RESOLUTION HOLDING HEARING ON REQUEST FROM DES MOINES COLD STORAGE COMPANY, INC. FOR APPROVAL OF PUD FINAL DEVELOPMENT PLAN FOR “PHASE 1A OF DES MOINES COLD STORAGE” FOR PROPERTY AT 3805 VANDALIA ROAD

Communication from the City Plan and Zoning Commission advising that at their meeting held March 5, 2020, the following action was taken regarding a request from Des Moines Cold Storage (owner) represented by CJ Morton (officer) for review and approval of a PUD Final Development Plan for "Phase IA of Des Moines Cold Storage" for property located at 3805 Vandalia Road, to allow a 62,680-square foot addition to the existing refrigerated warehouse building.

DES MOINES COLD STORAGE PHASE 2 SITE PLAN

DRAWING NO.
 SP-02

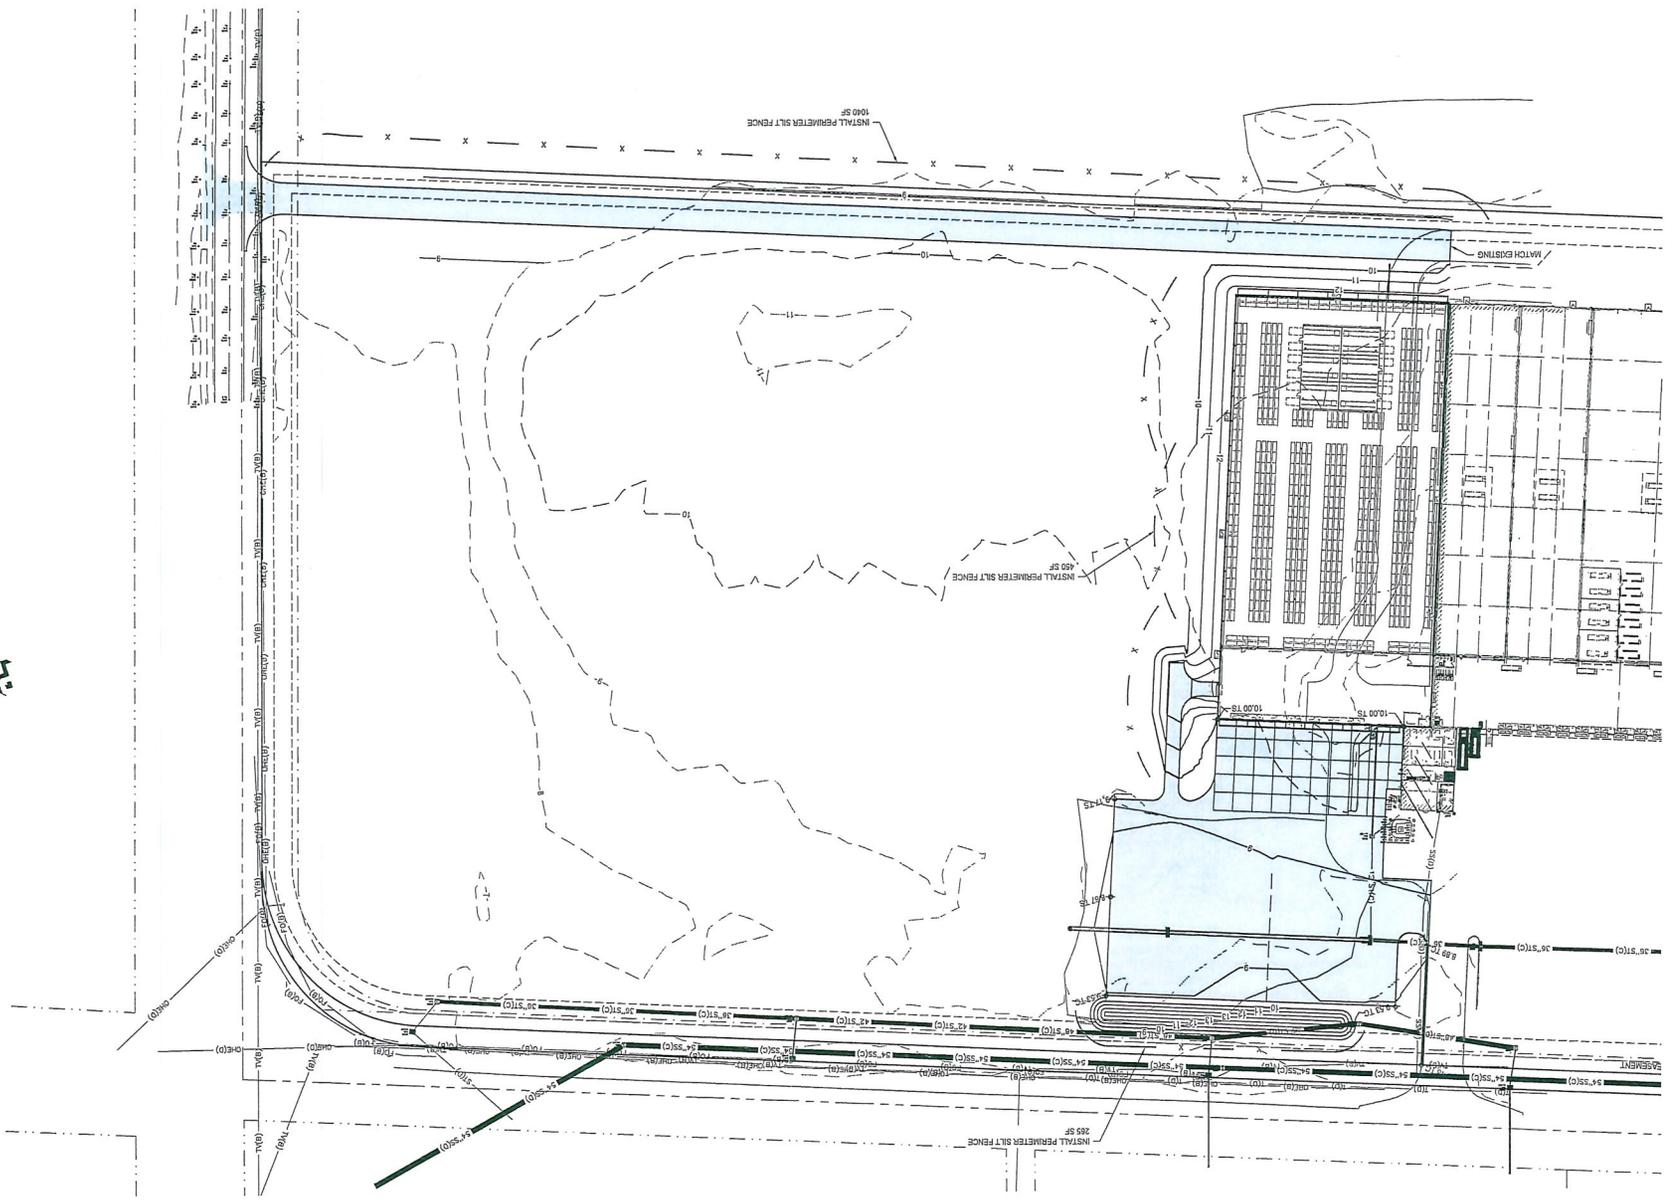
1. Compliance with all comments of the administrative review of the PUD Final Development Plan.
2. Provision of public sidewalk along Vandalia Road for the extent of the immediate Phase 1A extension.

Vandalia Road is a priority level 3 street in MoveDSM with regard to installation of pedestrian sidewalks. Traffic Engineering Staff have not required installation of public side walk along Vandalia Road on past projects. However, with the adoption of the complete streets policy they are recommending requirement of sidewalk installation with all projects where it does not currently exist, moving forward from that policy.

1
4
NORTH ELEVATION
SCALE: 1/16" = 1'-0"

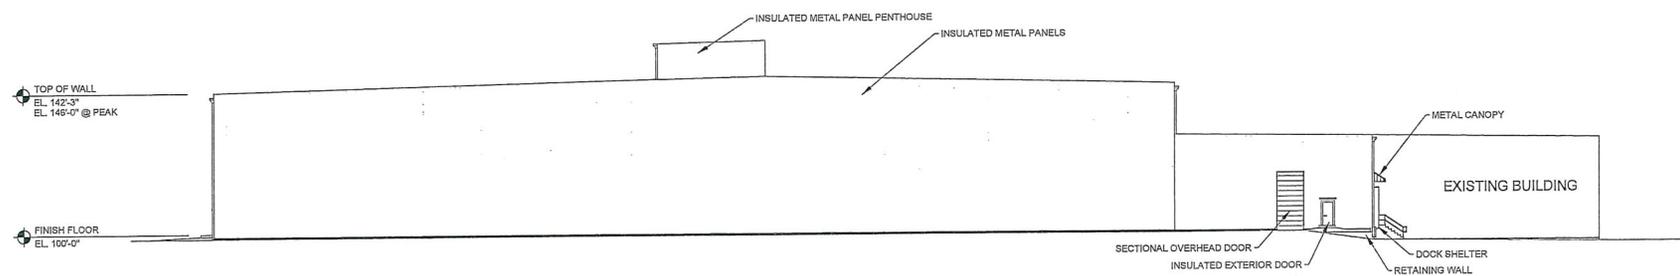
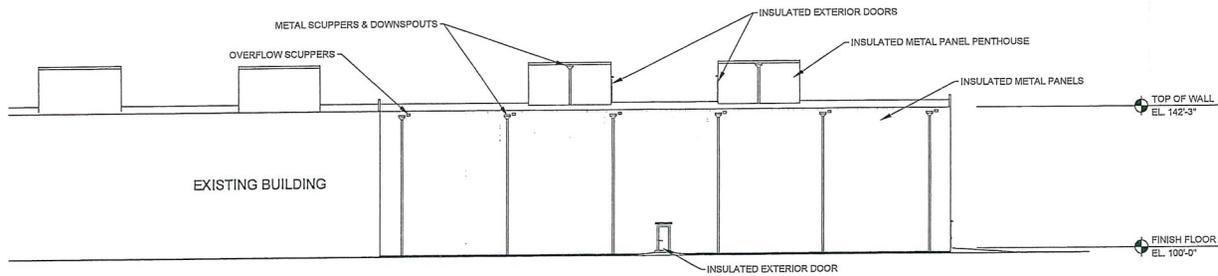
The submitted elevations also indicated a building that would be constructed of a beige metal panel design and EIFS with masonry accents on the front office building. While typically an industrial building in a planned district would be looked to be of a pre-cast concrete or masonry material, the nature of refrigerated storage presented difficulties in using that material efficiently and economically. The approved metal panel exterior is based on the need for refrigerated storage buildings.

The roof top mechanical systems are required by the PUD Conceptual Plan amendment to architecturally screened to be compatible with the overall building. The approved Conceptual Plan did not require lower mounted condenser units to be screened. There is additional condenser unit proposed to be mounted adjacent to the existing unscreened unit on top of the lower roof of the engine room. Based on the approved PUD Conceptual Plan, screening would not be required for this unit under the same circumstances.
